Bid Document Review: Drawing Markup

COLLIERS BID DOCUMENT REVIEW®

General, Architectural,
Landscaping and Structural

Comment #
F - 12

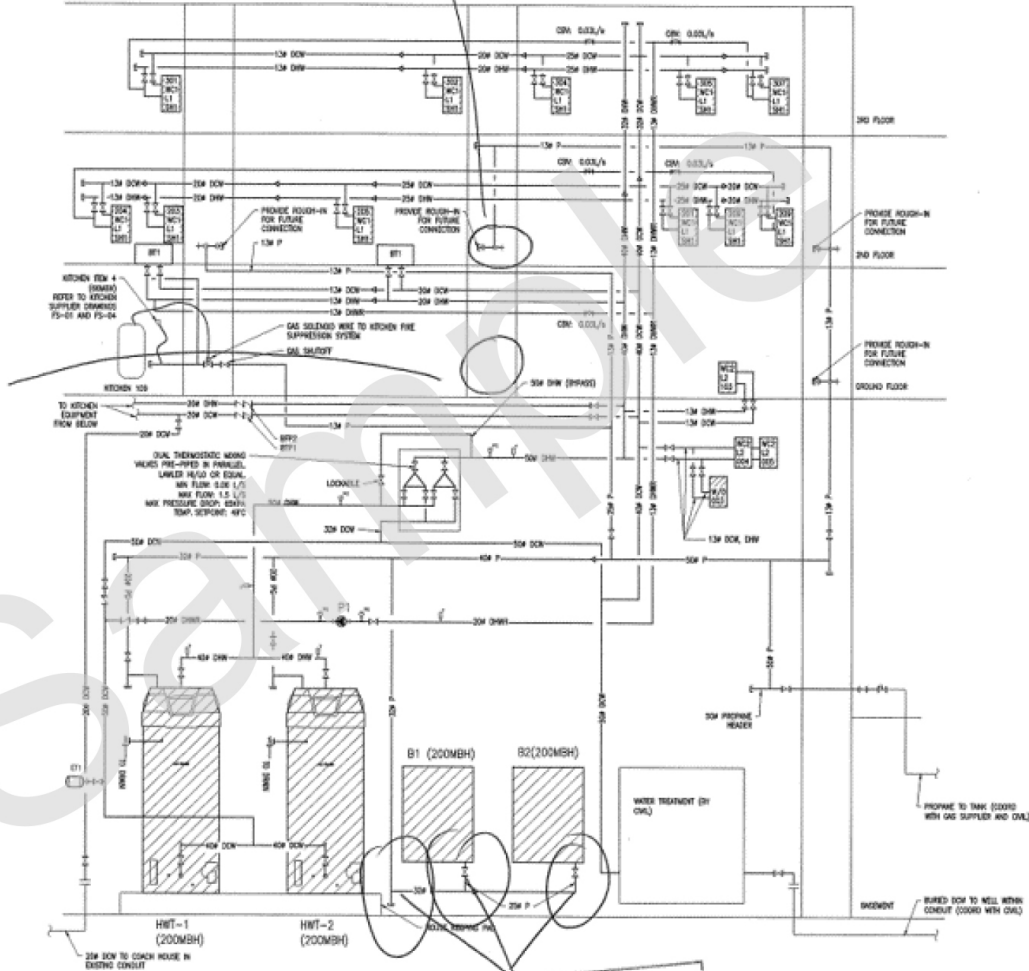
F	12		M305		Review valving arrangement to see if bypass can be achieved.					✓
